From: Dennis M. Postler <dennis.postler@tkda.com>
Sent: Thursday, June 18, 2020 2:49 PM
To: Elizabeth Mursko <cityadministrator@ci.columbus.mn.us>; Jim Windingstad <jwsuperintendent@ci.columbus.mn.us>
Cc: Larry Poppler <larry.poppler@tkda.com>
Subject: FW: N.698146 / MNCL19.80163E_Hornsby St Realignment-Columbus

**HORNSBY STREET
 NORTH REALIGNMENT**

DRAINAGE PLAN AND PROFILE
 TH 97 STA. 417+83.82 TO STA. 433+00

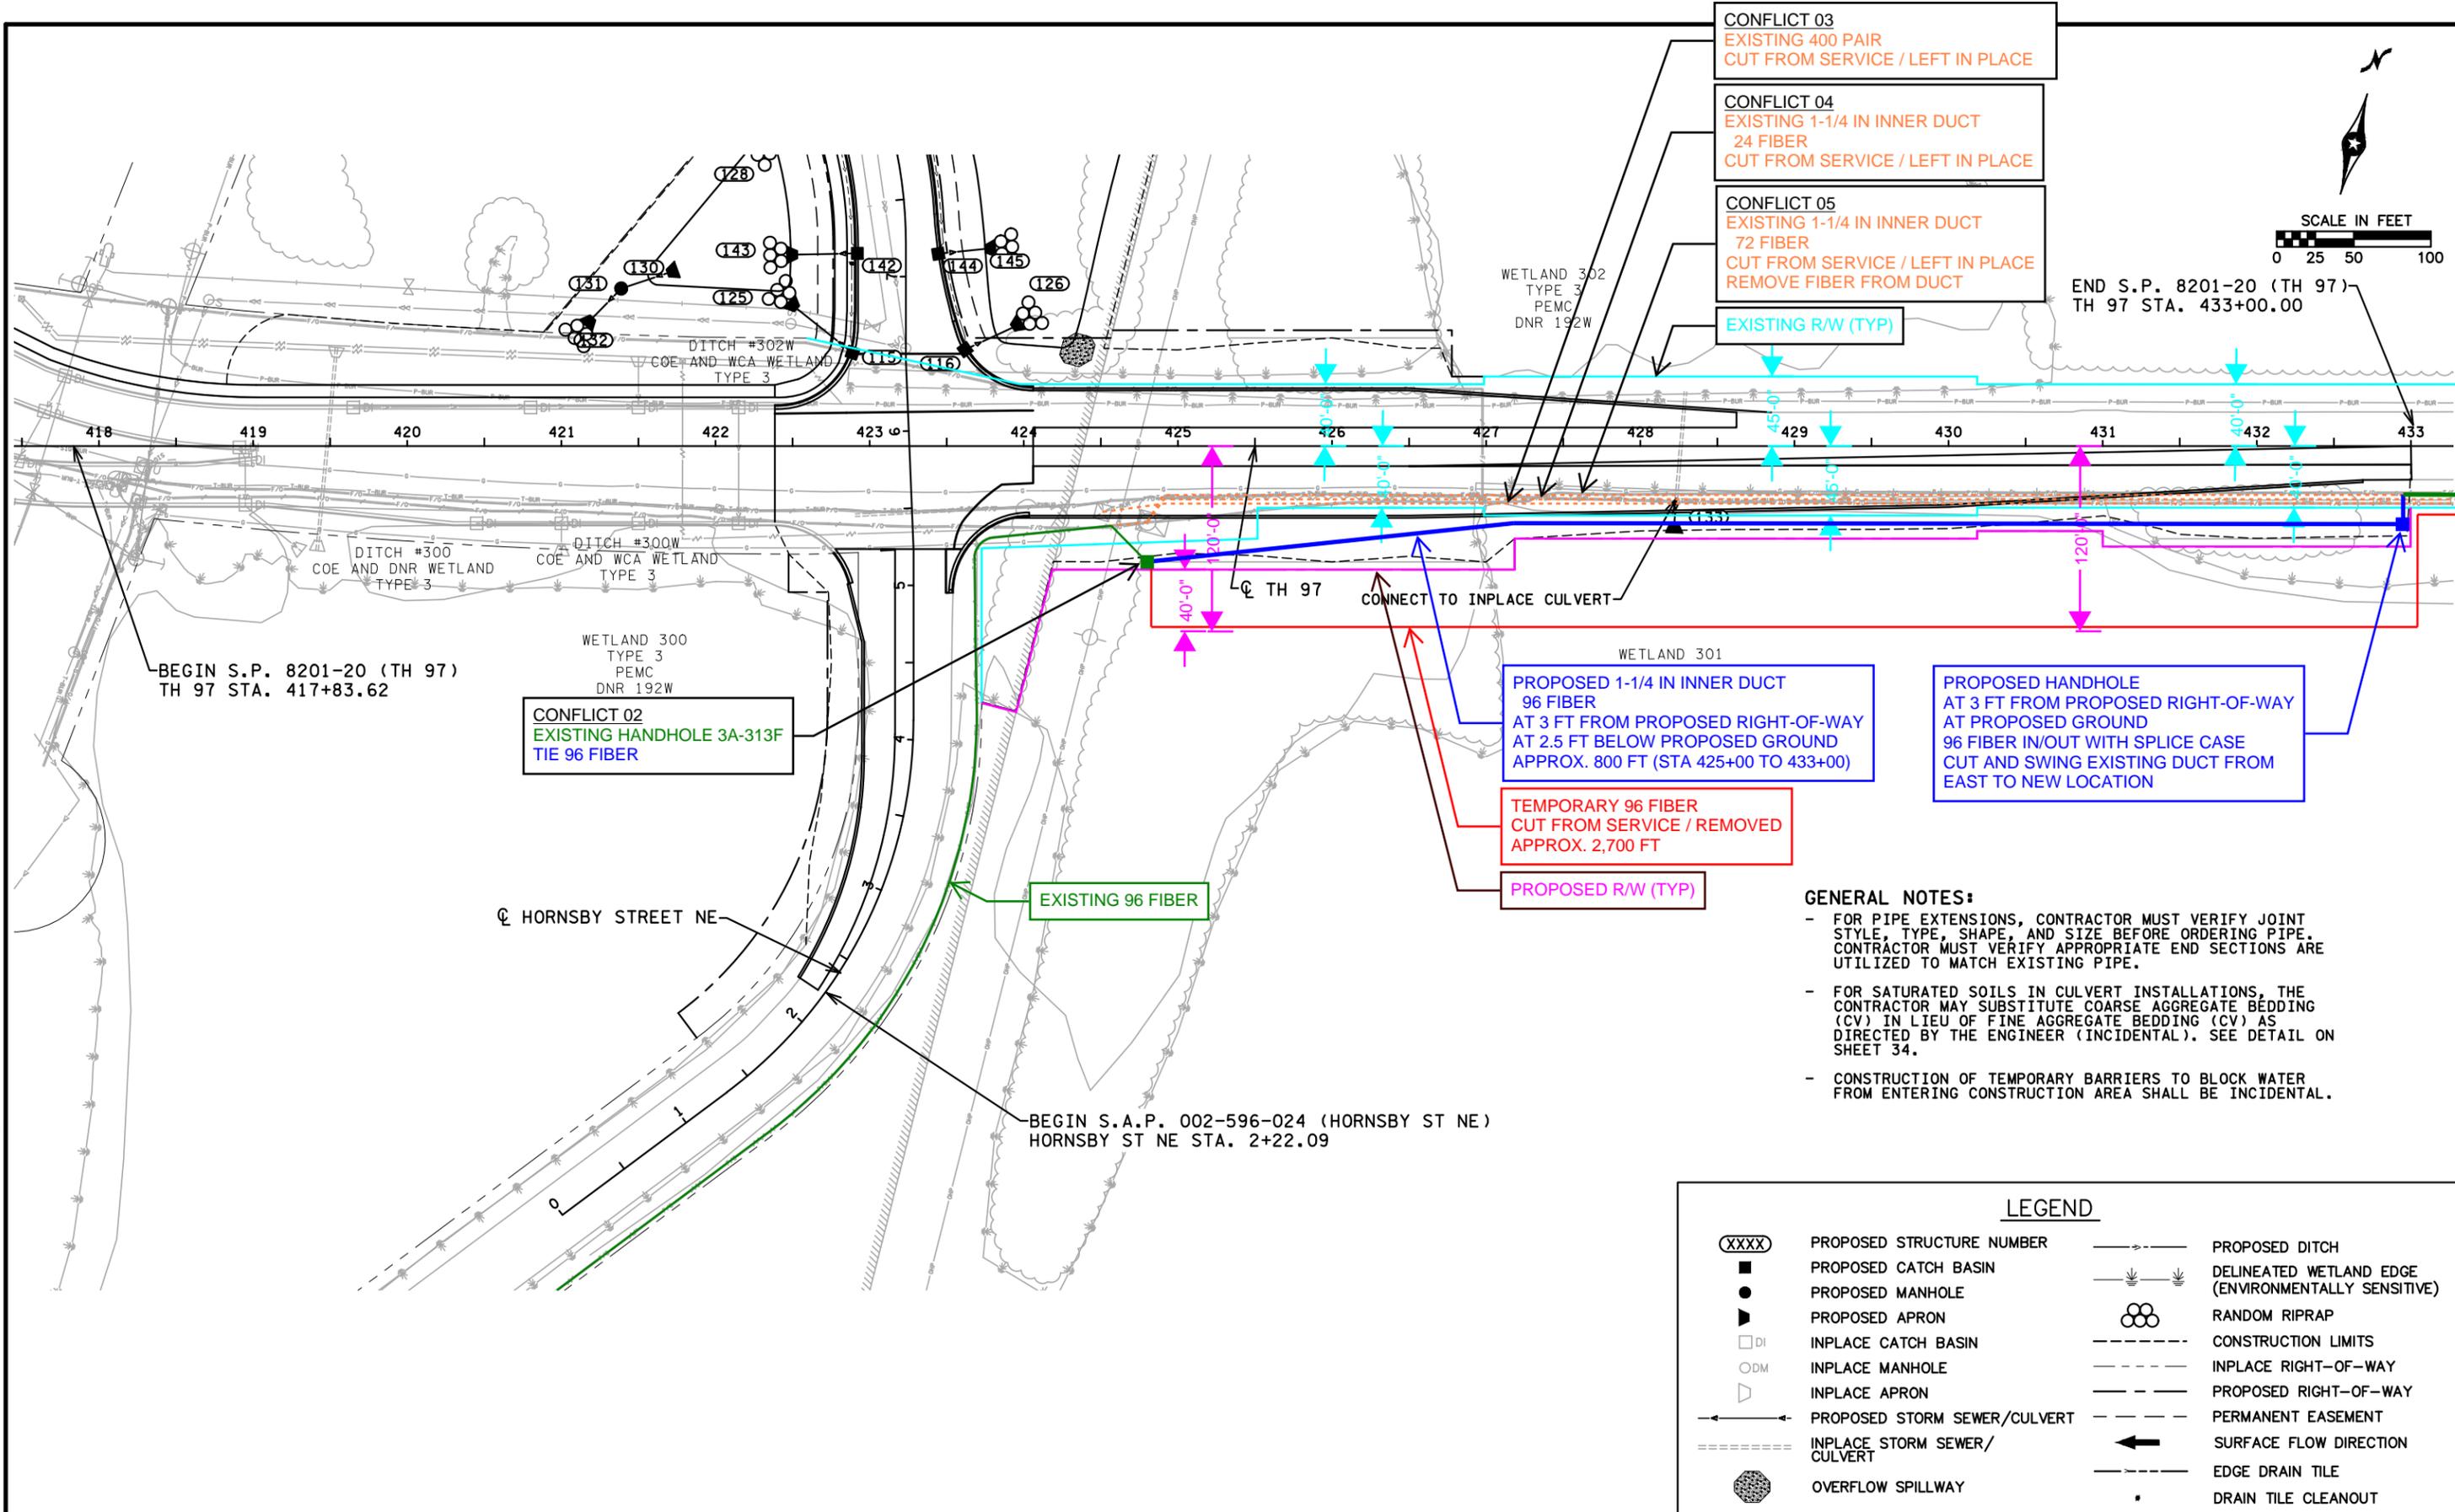
- CONFLICT 03**
EXISTING 400 PAIR
CUT FROM SERVICE / LEFT IN PLACE
- CONFLICT 04**
EXISTING 1-1/4 IN INNER DUCT
24 FIBER
CUT FROM SERVICE / LEFT IN PLACE
- CONFLICT 05**
EXISTING 1-1/4 IN INNER DUCT
72 FIBER
CUT FROM SERVICE / LEFT IN PLACE
REMOVE FIBER FROM DUCT

CONFLICT 02
EXISTING HANDHOLE 3A-313F
TIE 96 FIBER

PROPOSED 1-1/4 IN INNER DUCT
96 FIBER
AT 3 FT FROM PROPOSED RIGHT-OF-WAY
AT 2.5 FT BELOW PROPOSED GROUND
APPROX. 800 FT (STA 425+00 TO 433+00)

PROPOSED HANDHOLE
AT 3 FT FROM PROPOSED RIGHT-OF-WAY
AT PROPOSED GROUND
96 FIBER IN/OUT WITH SPLICE CASE
CUT AND SWING EXISTING DUCT FROM
EAST TO NEW LOCATION

TEMPORARY 96 FIBER
CUT FROM SERVICE / REMOVED
APPROX. 2,700 FT

CONSTRUCTION PLAN

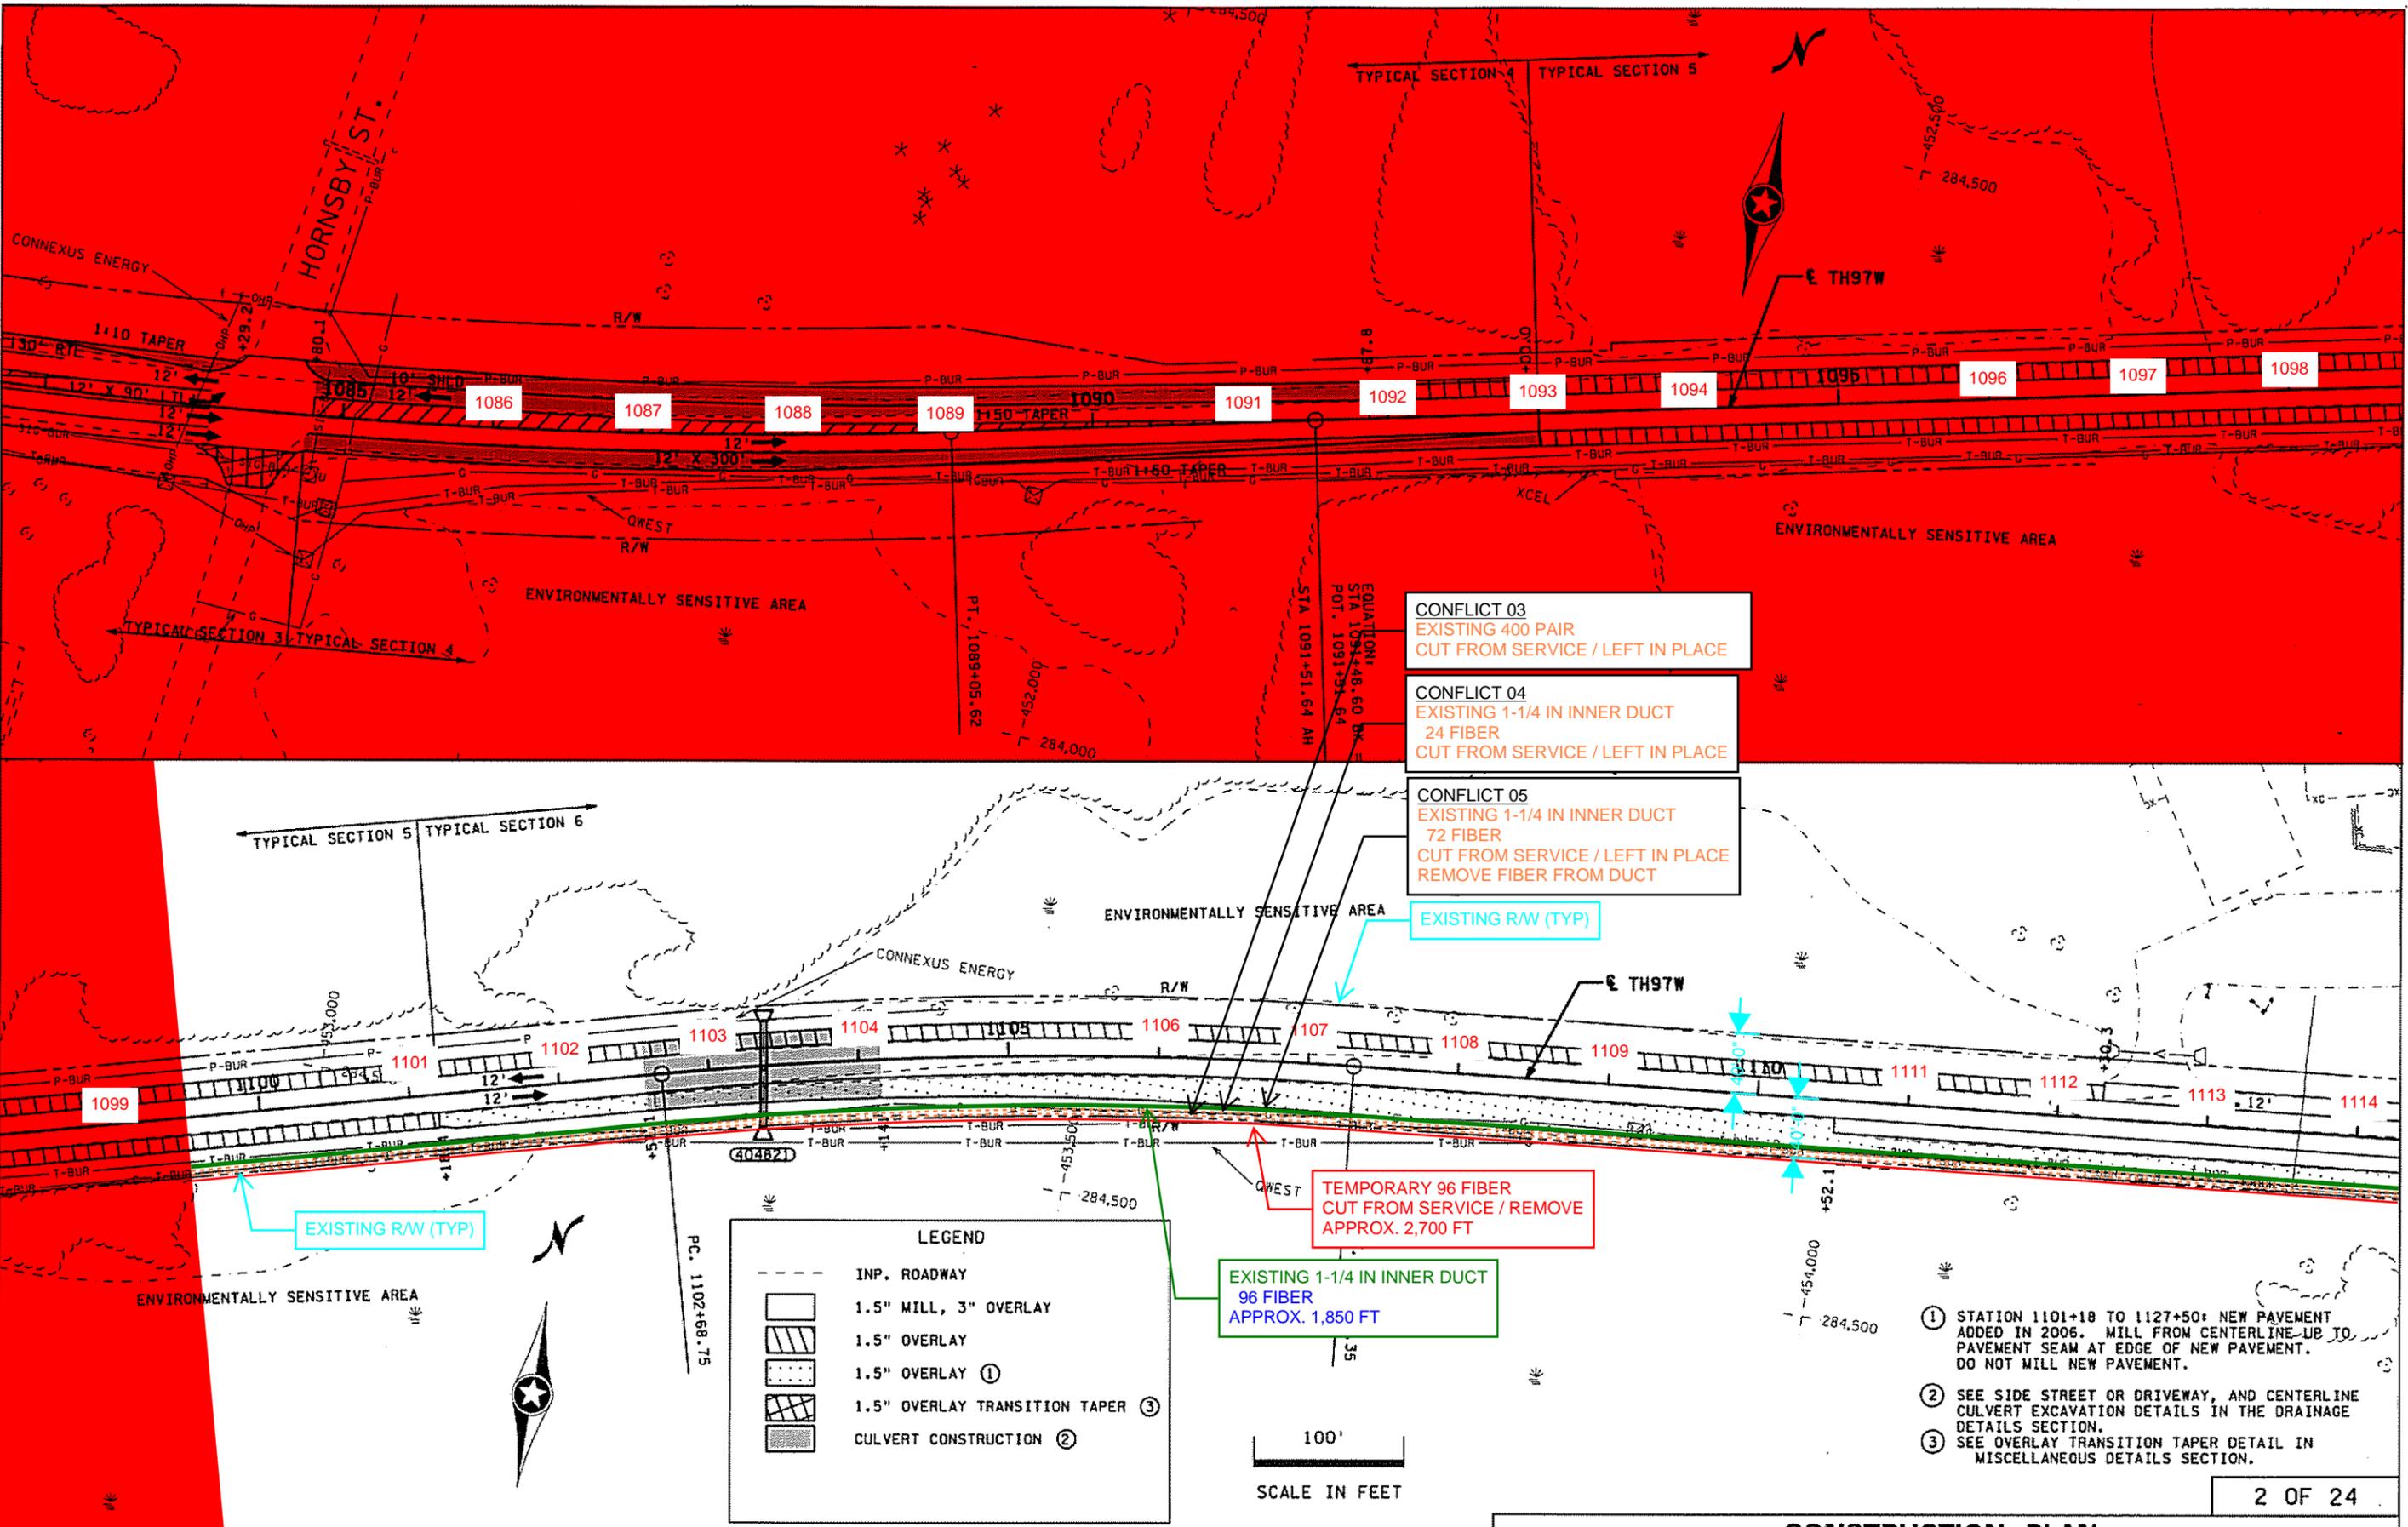
CONFLICT 03
EXISTING 400 PAIR
CUT FROM SERVICE / LEFT IN PLACE

CONFLICT 04
EXISTING 1-1/4 IN INNER DUCT
24 FIBER
CUT FROM SERVICE / LEFT IN PLACE

CONFLICT 05
EXISTING 1-1/4 IN INNER DUCT
72 FIBER
CUT FROM SERVICE / LEFT IN PLACE
REMOVE FIBER FROM DUCT

TEMPORARY 96 FIBER
CUT FROM SERVICE / REMOVE
APPROX. 2,700 FT

EXISTING 1-1/4 IN INNER DUCT
96 FIBER
APPROX. 1,850 FT
